UNITED STATES
NUCLEAR REGULATORY COMMISSION
WASHINGTON, D. C. 20555

The Commission has issued the enclosed Amendments No. 12 to Facility Operating Licenses Nos. DPR-32 and DPR-37 for the Surry Power Station, Units 1 and 2. The amendments include Change No. 27 to the Technical Specifications for each license and are in response to your request dated October 22, 1975.

The amendments revise the provisions in the Technical Specifications relating to the heatup and cooldown limitations of the reactor coolant system.

ATTACHMENT TO LICENSE AMENDMENT NO. 12
CHANGE NO. 27 TO THE TECHNICAL SPECIFICATIONS
FACILITY OPERATING LICENSE NO. DPR-32
DOCKET NO. 50-280

TS FIGURE 3.1-1

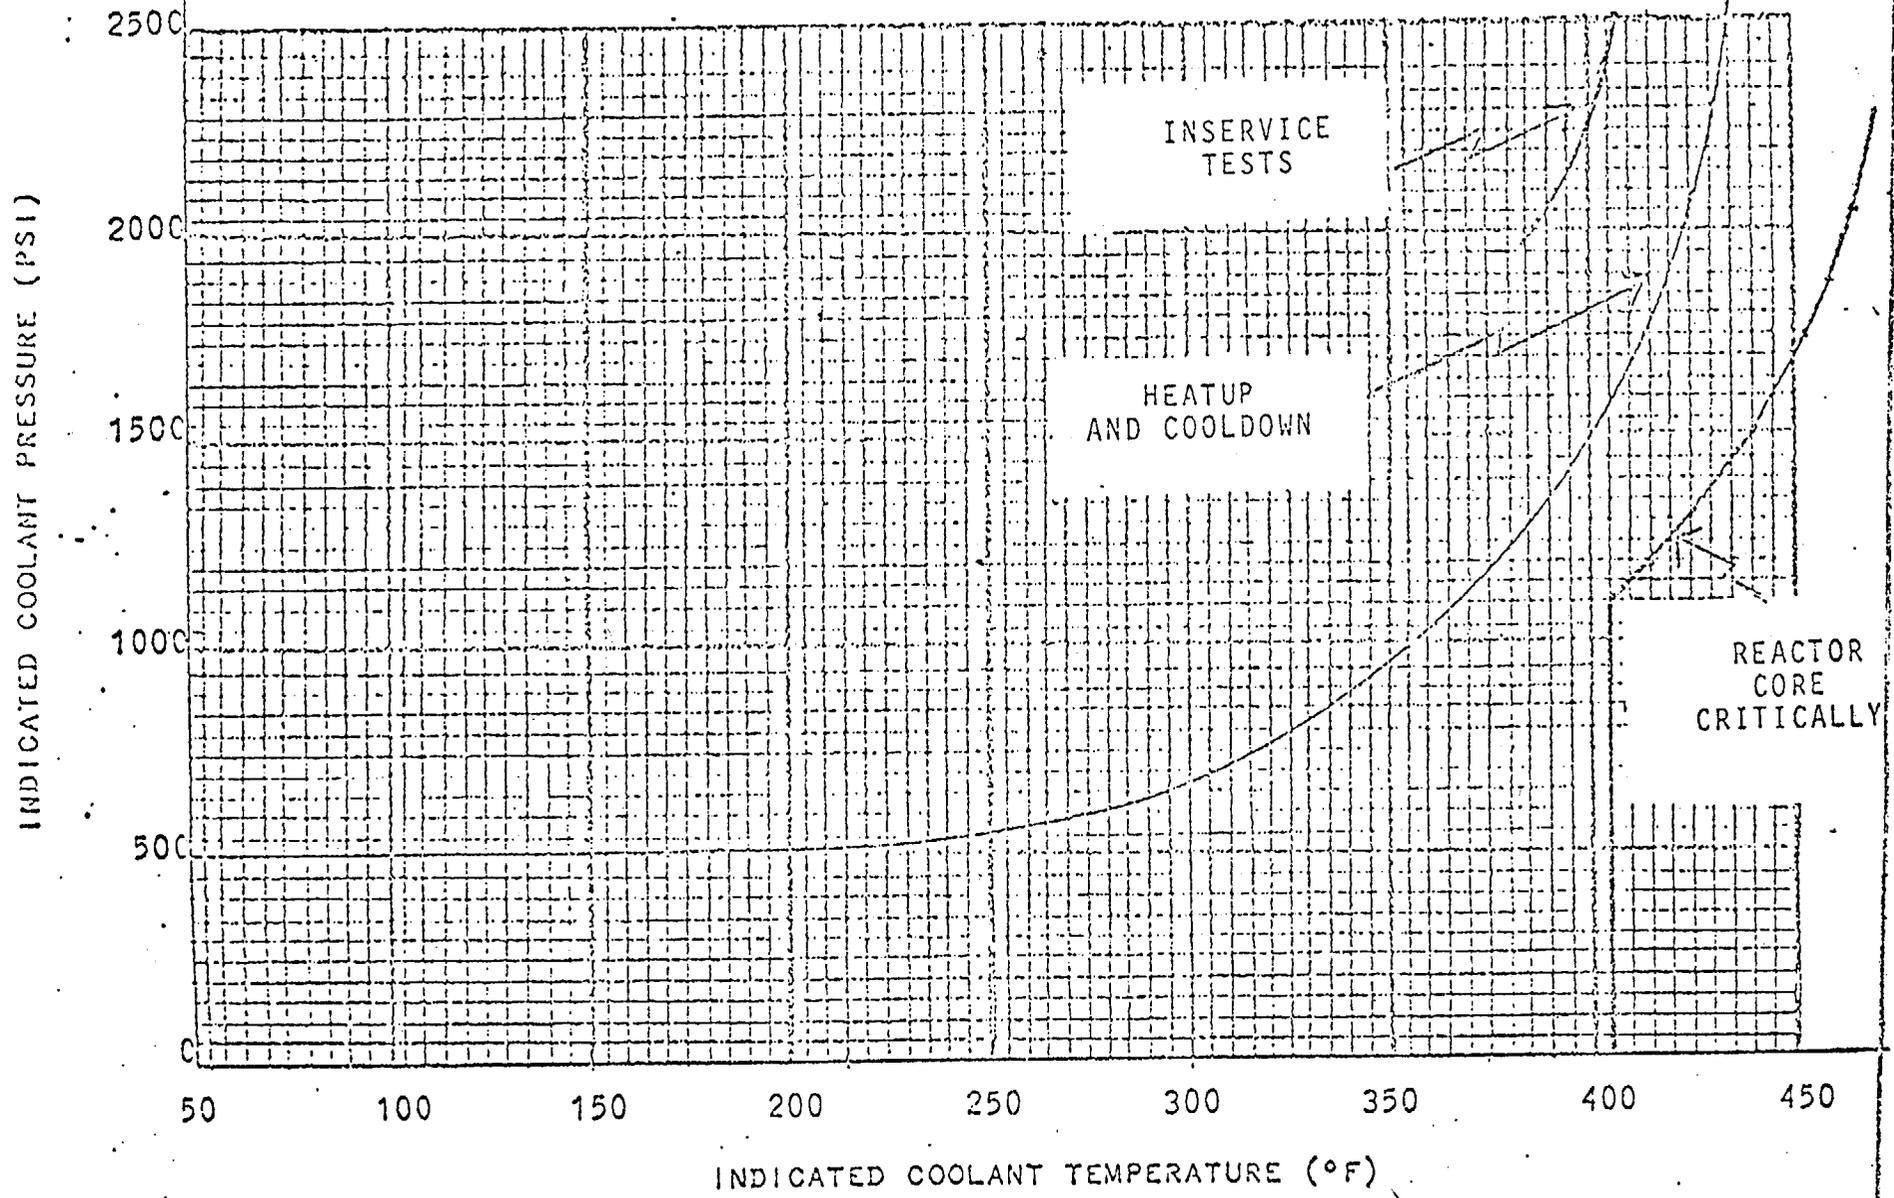
We have evaluated the pressure-temperature limit curve presented in Figure 3.1-1 of the licensee's proposed Technical Specification Change of October 22, 1975 and conclude that it is acceptable for heatup and cooldown pressure-temperature limits. We have augmented this curve to indicate pressure-temperature limits for inservice hydro testing and core criticality. The attached curves provide acceptable limits for these conditions.

The following paragraph has been added to Specification 3.1.B.1:

"Core Operation:

During operation where the reactor core is in a critical condition (except for low level physics tests), vessel metal and fluid temperature shall be maintained above the reactor core criticality limits specified in Figure 3.1-1."

The following statement has been added to Specification 4.3.A:

"The pressure-temperature limits for these tests will be in accordance with Figure 3.1-1."

1. Unit 1 and Unit 2 reactor coolant temperature and pressure and the system heatup and cooldown (with the exception of the pressurizer) shall be limited in accordance with TS Figure 3.1-1.

Figure 3.1-1 may be used for heatup rates of up to 50°F/hr. below an indicated temperature of 440°F and 100°F/hr. above 440°F.

Allowable combinations of pressure and temperature for specific cooldown rates are below and to the right of the limit line as shown in TS Figure 3.1-1. This rate shall not exceed 50°F/hr. for temperatures at or below an indicated temperature of 440°F. For temperatures above an indicated temperature 440°F, the rate shall not exceed 100°F/hr.

During operation where the reactor core is in a critical condition (except for low level physics tests), vessel metal and fluid temperature shall be maintained above the reactor core criticality limits specified in Figure 3.1-1.

The pressure-temperature limits for inservice tests, heatup and cooldown and core operation contained in the licensee's Technical Specification Change of October 22, 1975 with the above revisions comply with the requirements of Appendix G, 10 CFR Part 50 and are acceptable. The use of Appendix G in establishing safe operating limitations will ensure adequate safety margins during operation, testing, maintenance and postulated accident conditions and constitute an acceptable basis for satisfying the requirements of NRC General Design Criterion 31, Appendix A, 10 CFR Part 50.
